CARLO GAVAZZI SPACE SpA	<b>AMS02-PDS</b>		N° Doc: <b>PDS-RP-CGS-120</b> Doc N°:	
	PDS-PFM THERMAL VACUUM TEST REPORT		Ediz.: <b>1</b> Issue:	Data: <b>SEPT 2009</b> Date:
			Pagina <b>29</b> Page	di <b>29</b> of

### ANNEX 3: PVS COLLECTION

## PROCEDURE VARIATION SHEET ref. N°: 01

Procedure Ref.: PDS-PR-CGS-012

## PROCEDURE VARIATION SHEET ref. N°: 02

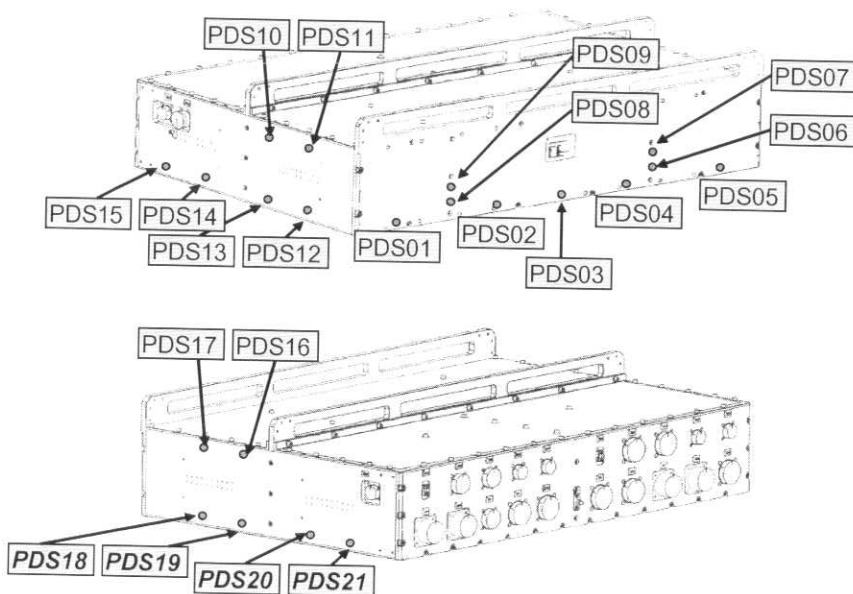
Description of Change: **SENSOR NUMBERING**

Numbering of PT100 thermal sensors has been updated as follows:

old number → New number

PDS17 → PDS18

PDS18 → PDS19

PDS19 → PDS20

PDS20 → PDS21

PDS21 → PDS22

PDS22 → PDS23

PDS23 → PDS24

PDS24 → PDS25

The new figures are given below:

Reason for Change:

Fig 6-8 and Fig 6-9 are wrong because of the presence of two different sensors, both numbered PDS17.
